**SANDMOUND SYSTEM**  
**ON-SITE SEWAGE DISPOSAL SYSTEM**  
**HOWARD COUNTY HEALTH DEPARTMENT**  
**BUREAU OF ENVIRONMENTAL HEALTH**

ADDRESS: 1380 Driver Road PROPERTY OWNER: Mr. Gmeinwieser

**LOCATION DRAWING**  
of  
**1380 DRIVER ROAD**  
HOWARD COUNTY, MD.

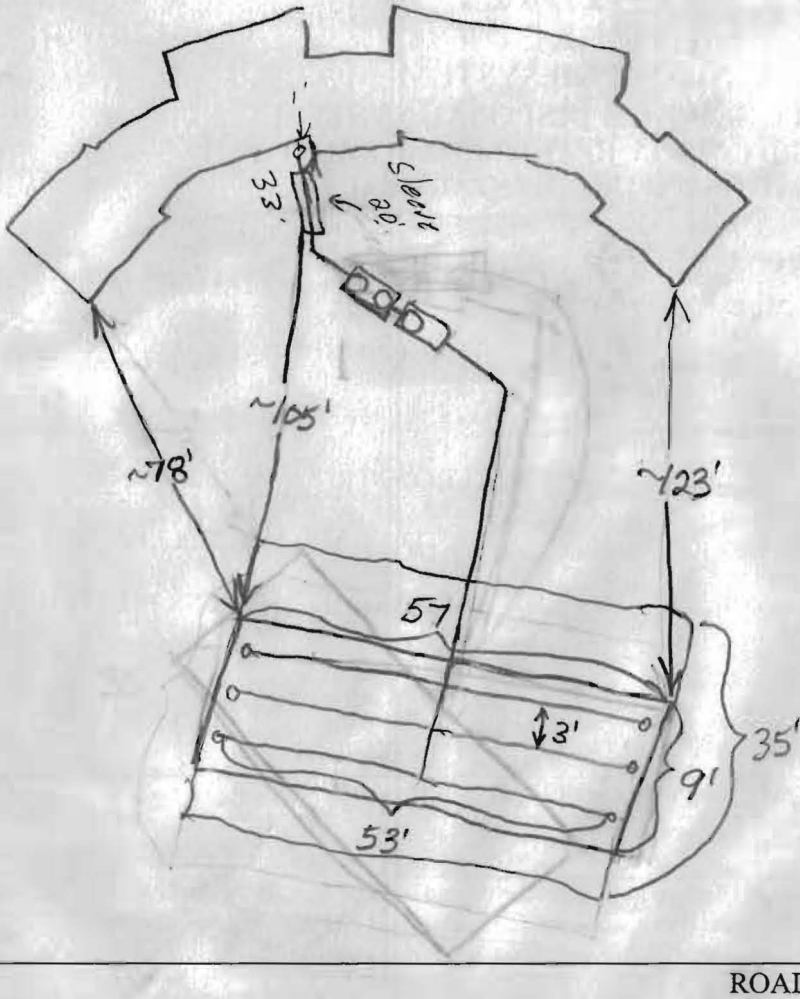
Need Front Baffle  
 In First Tank and  
 Tee in second Tank  
 Need Additional Wire  
 For Event Timer

PRE-CONSTRUCTION 7/2/04 - Sand mount corners & laterals staked  
 (2) lower corners on 1st S.M. in driveway, (1) upper corner on  
 INSTALLATION 2nd S.M. 1' in common drive, Job shut down (SO)  
7/9/04 - be-pave, see sheet. Tanks set (SO) 7/12/04  
Sand installed, starting on gravel bed, 3" force main  
installed (SO) 7/13/04. 3" lateral separation. Mound needs cap,  
and pump and alarm test. Need tank baffle and tee. Another wire  
needs to be run to pump tank for event timer. A load of sand  
was delivered for mound cap by mistake - told Toggles not touch. (RB)  
8/6/04 - Pump & Alarm tests OK (SO)  
 FINAL INSPECTOR [Signature] DATE OF APPROVAL 8/6/04
